# WATER QUALITY MEMORANDUM

## Utah Coal Regulatory Program

RE: Second Quarter 2018 Water Monitoring, Wolverine Fuels, Fossil Rock Mine, C/015/0009, Task ID #5752

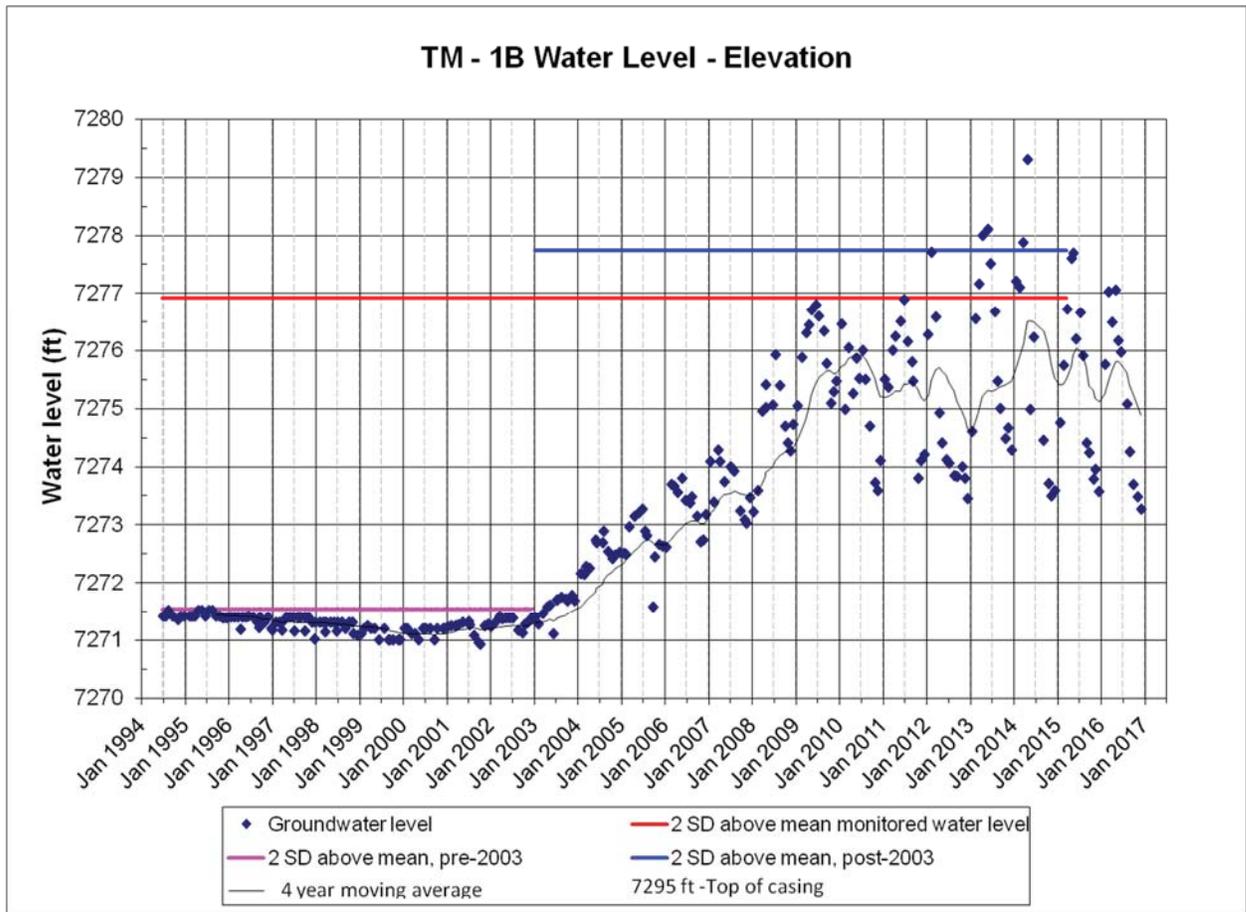
Figure 1. The water level in TM-1B has been rising since mine dewatering ceased in May 2001. It's difficult to say where the water level will come to rest. The well is completed in the Panther tongue of the Star Point sandstone below the mine workings. This sandstone tongue contacts the floor of the mine workings. Mine dewatering reduced the potentiometric head within the unit and the mine pool is probably recharging the unit. This graph will be updated when mining begins in the Cottonwood Track.

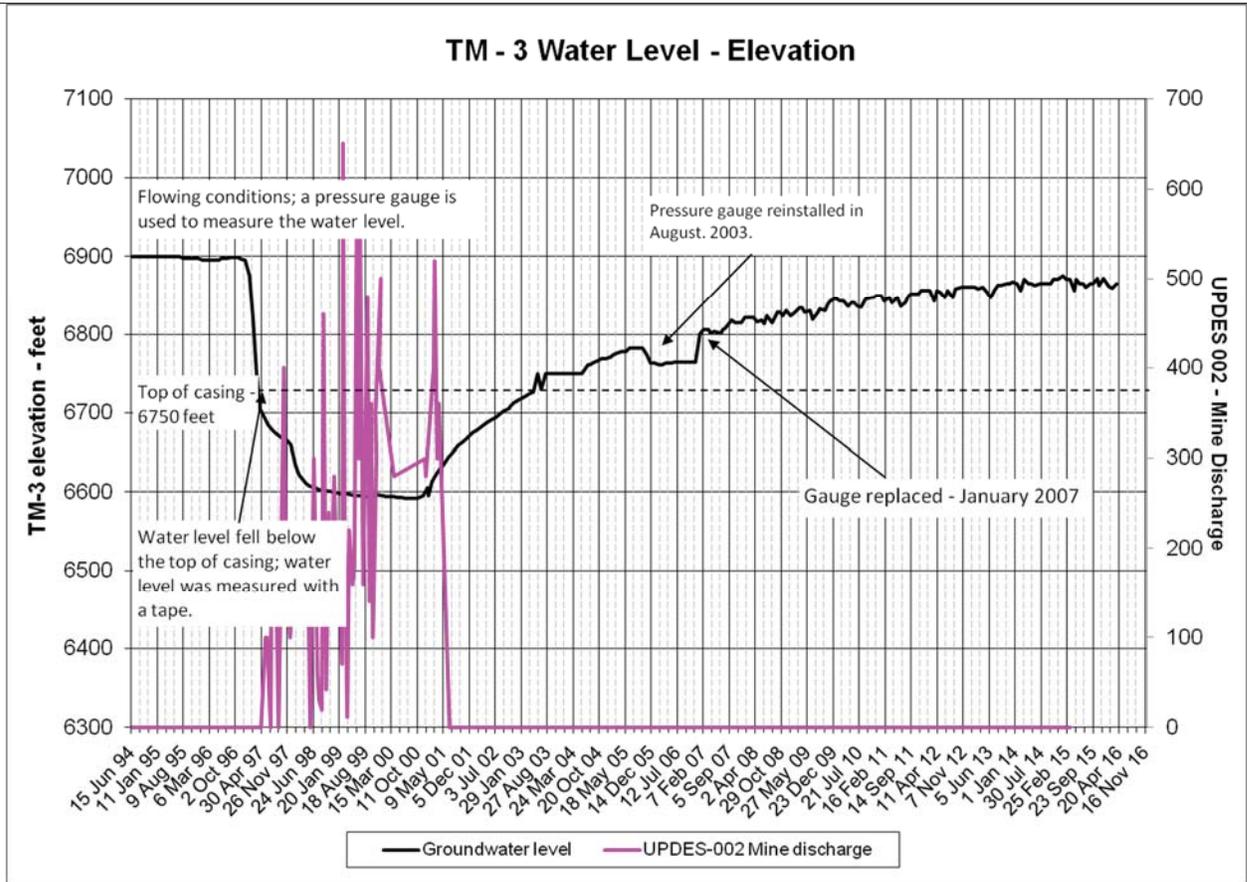
Figure 2. TM-3 water elevation peaked in June 2005, remained steady through October, dropped 18.5 ft in November and December 2005 and remained virtually unchanged during 2006. The pressure gauge was replaced in January 2007 and values jumped to approximately match the pre-2006 curve. During the first half of 2007 the curve was relatively flat, but it has been steadily climbing. The outgoing document Reduce Hydrologic Monitoring Sites, PacifiCorp, Deer Creek, C/015/0018, Task ID #4332 stipulates this well should not be released until 6,900 ft is reached. This graph will be updated when mining begins in the Cottonwood Track.

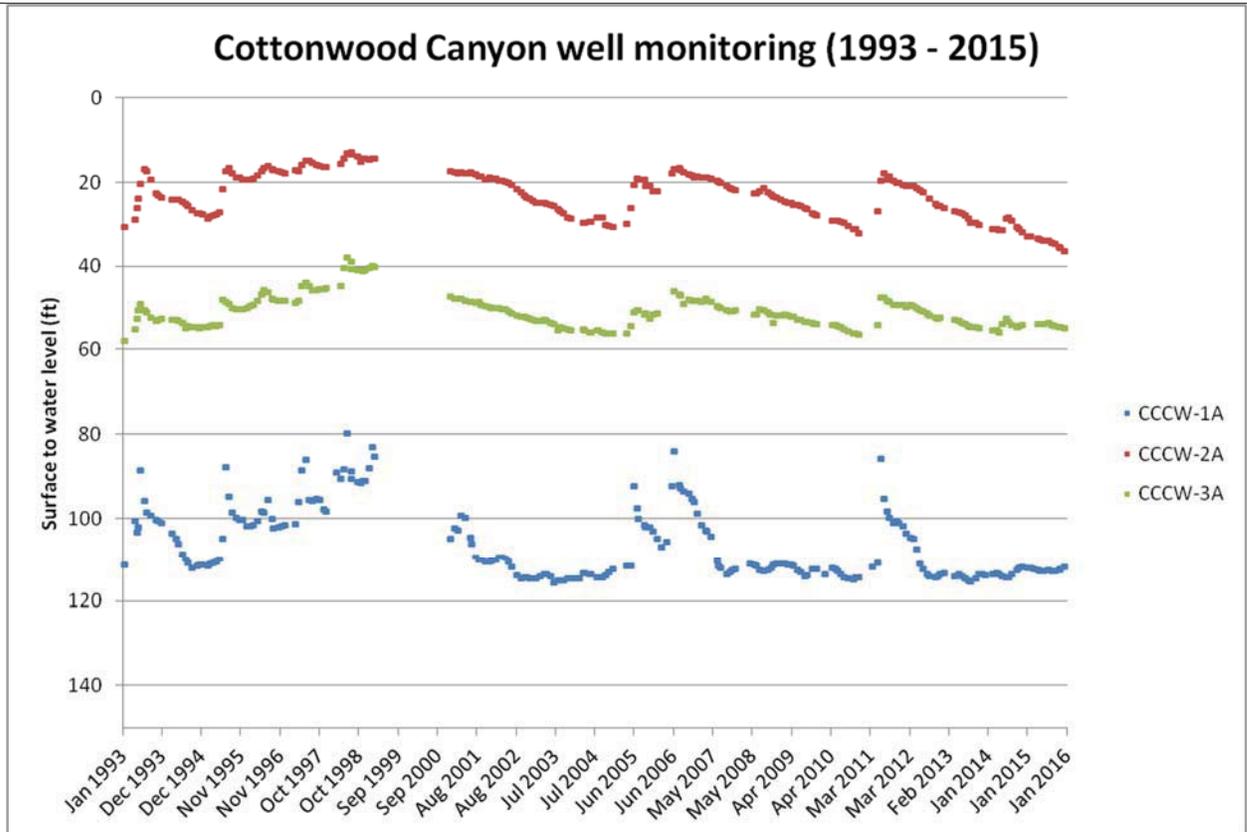
– 2A, CCCW – 3A, CCCW – 3U, CCCW – 3L are monitored for water level only (Figure 3 shows alluvial wells).

The CCCW wells were not monitored during June 2018. The Trail Mountain wildfire closed access to the canyon in early June when the fire started.

Figure 3. Alluvial aquifer water levels in the Cottonwood Canyon Creek monitoring wells. The drill hole data is found in Trail Mountain MRP Appendix C p. 23. This graph will be updated when mining begins in the Cottonwood Track. At this time the wells are primarily responding to climatic variability.
